# County of Fairfax, Virginia

## **STAFF REPORT**

### **APPLICATION RZ/FDP 2013-HM-012**

**PROPOSAL:** To rezone from the R-1 District to the PDH-2 District to construct nine single-family detached dwellings at a density of 1.66 dwelling units per acre (du/ac)

# STORMWATER MANAGEMENT INFORMATION

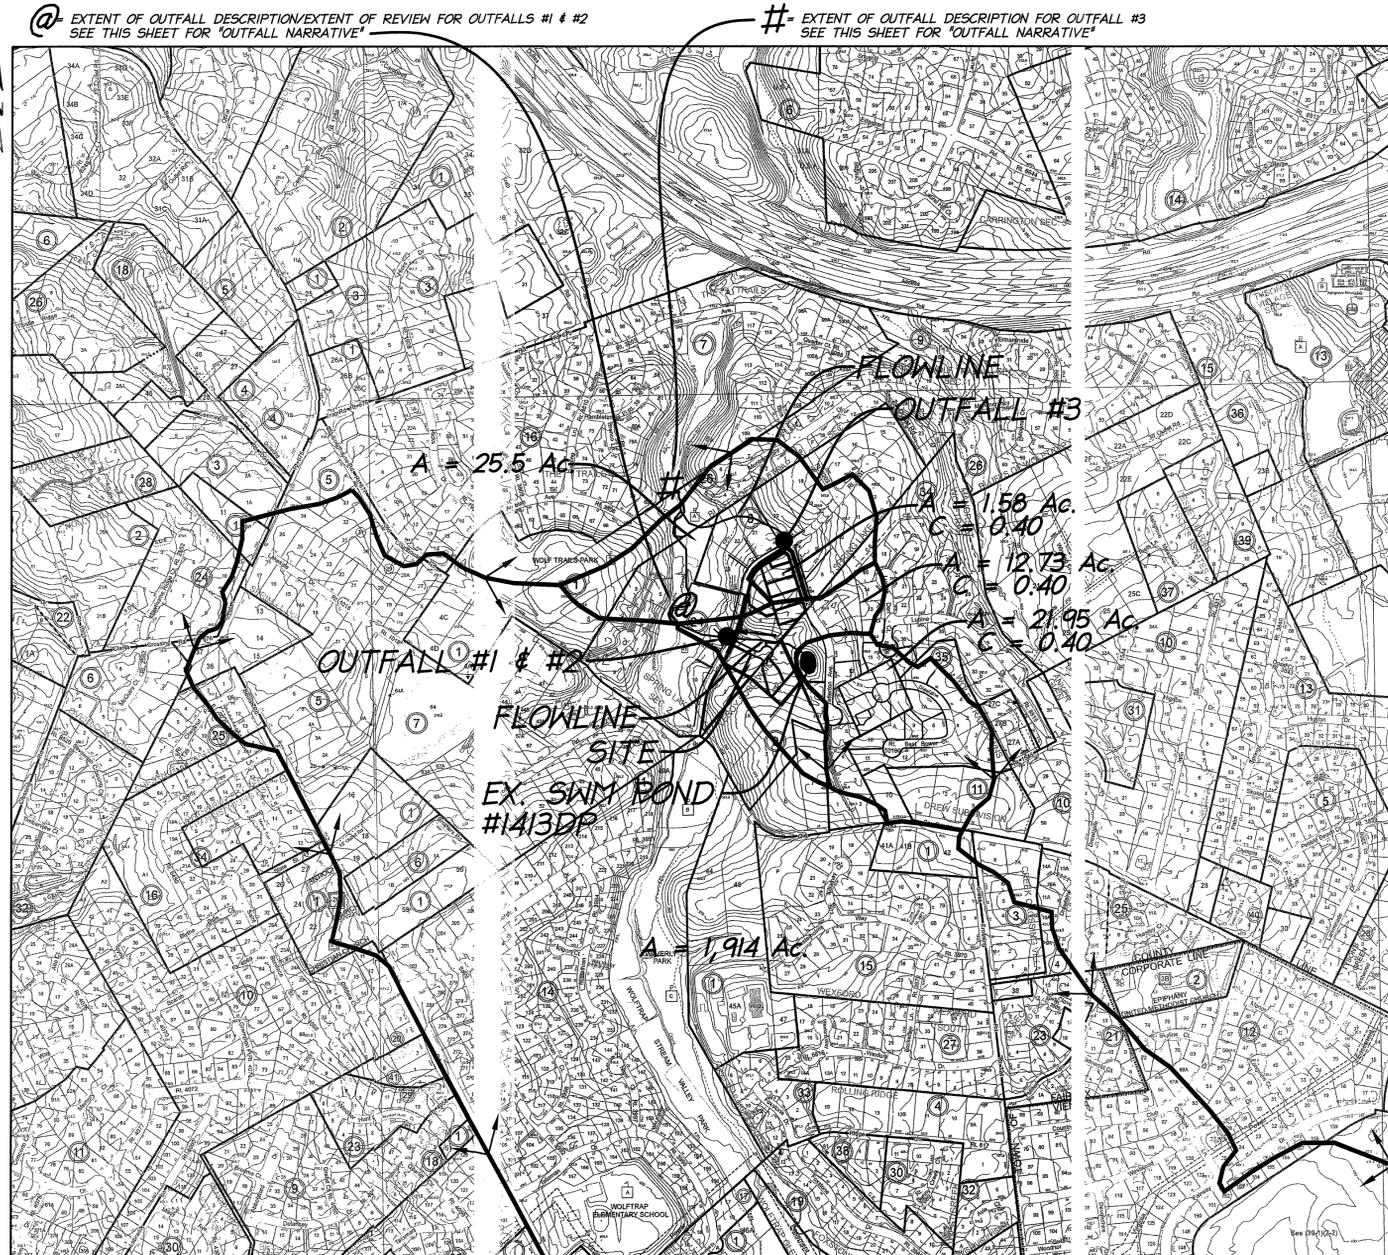
The stormwater management narrative on Sheet 7 of the CDP/FDP states that the infiltration trenches and bio-retention filter have been designed for the 10-year, 2 hour storm in order to provide detention for the 1, 2, and 10-year storm events and meet the BMP requirements of the PFM. Although the final calculations will be provided with the subdivision plan, the CDP/FDP indicates that the post-development runoff will be less than the pre-development runoff and a minimum of 40% phosphorus removal will be achieved, as required by the PFM. The CDP/FDP states that outfalls are adequate in accordance with the PFM and the proffers state that the stormwater facility shall be designed to meet the adequate outfall requirements as outlined in the PFM.

The applicant has stated that an adequate outfall narrative has been provided on the CDP/FDP and that the post-development runoff will be less than pre-development runoff. The applicant has also stated in response to the comment regarding the on-site channel that the application area represents less than 10% of the contributing drainage area. In reference to the location of the infiltration trench and bio-retention filter, the applicant indicates that the locations have been field tested. Staff from DPWES commented that the existing outfall would be considered inadequate by PFM standards if the outfall has existing erosion problems. The applicant will be required to provide a drainage system that precludes adverse impact on downstream properties or the receiving channel in order to meet the PFM standards. In cases where the downstream facilities are inadequate, the applicant will need to design a storm drainage system that demonstrates there will be no adverse impacts and at least a minimum required proportional improvement is achieved pursuant to the PFM. The final engineering of any stormwater facilities will be subject to review and approval by DPWES at the time of subdivision plan.

Staff from the Fairfax County Park Authority commented that the applicant should provide underdrains with the design of the infiltration and bio-retention filter facilities (Appendix 9). Underdrains can be useful to handle overflow and could be needed if the soil has a very slow rate of infiltration. Staff from DPWES clarified that some sites cannot accommodate underdrains or are often not necessary when the existing soil has good infiltration properties. Specific design features such as underdrains, therefore, are looked at during final engineering of such facilities. As a result, staff has proposed a development condition that would require the applicant to provide underdrains with the design of the infiltration and bio-retention filter facilities if recommended by DPWES at the time of subdivision plan when more detailed information regarding the grading and infiltration rates is available.

#### Orientation of the proposed dwelling units to adjacent streets and homes

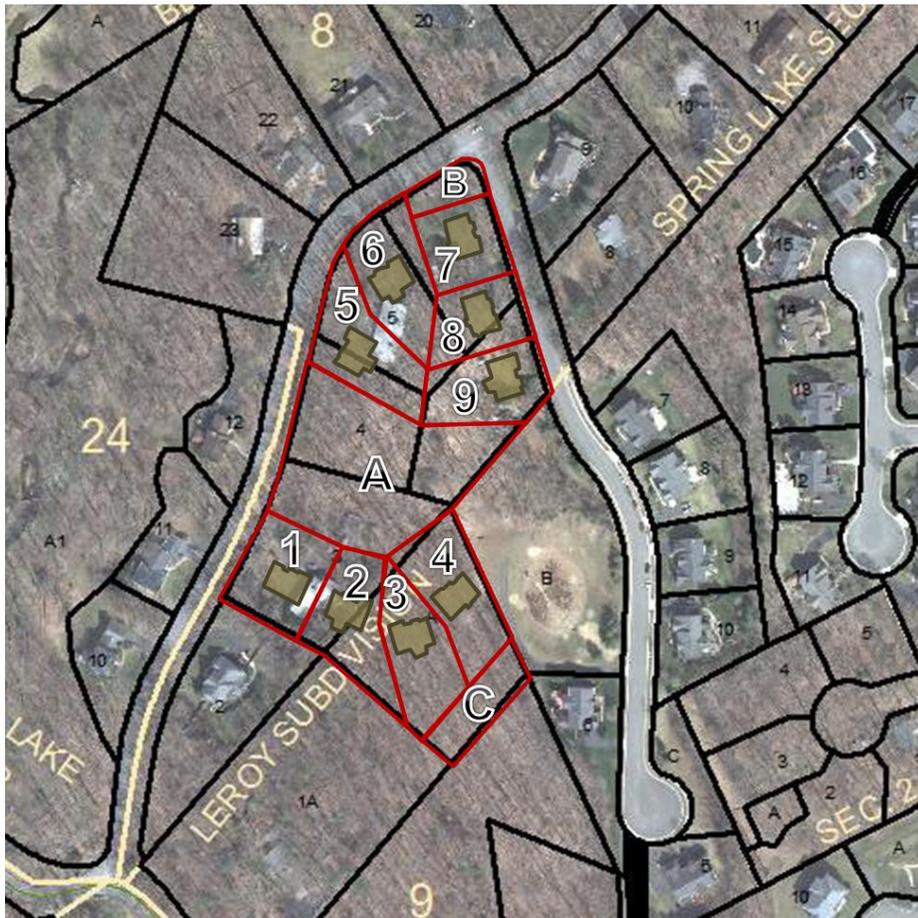
In staff's opinion, the proposed dwellings along Besley Road and Tetterton Avenue are appropriately oriented toward the street and the adjacent dwellings. In addition, the

proposed dwellings on Lots 1 – 4 are properly oriented along the proposed private street and around the cul-de-sac that would terminate on the subject property. As a result, in staff's opinion the proposed dwellings are logically oriented in terms of their relationship to adjacent streets and homes. Because the sides of the proposed dwellings on Lots 1 and 7 are adjacent to Besley Road, staff requested that the applicant provide landscaping and architectural treatment to screen the proposed dwelling from Besley Road and any adjacent homes. The applicant's CDP/FDP depicts two large evergreen trees, two large deciduous trees, and four Category four deciduous trees along the western side of Lot 1. In addition, the applicant has proffered to provide architectural treatments for the side facades on Lots 1 and 7 similar to those provided for the front facades.

The proposed dwelling on Lot 7 is oriented such that the rear of this dwelling faces the side of the dwelling on Lot 6. Staff requested that the applicant buffer the rear of this dwelling by providing for additional landscaping or using special architectural treatment. The applicant's revised proffers commit to providing three large deciduous trees behind Lot 7.
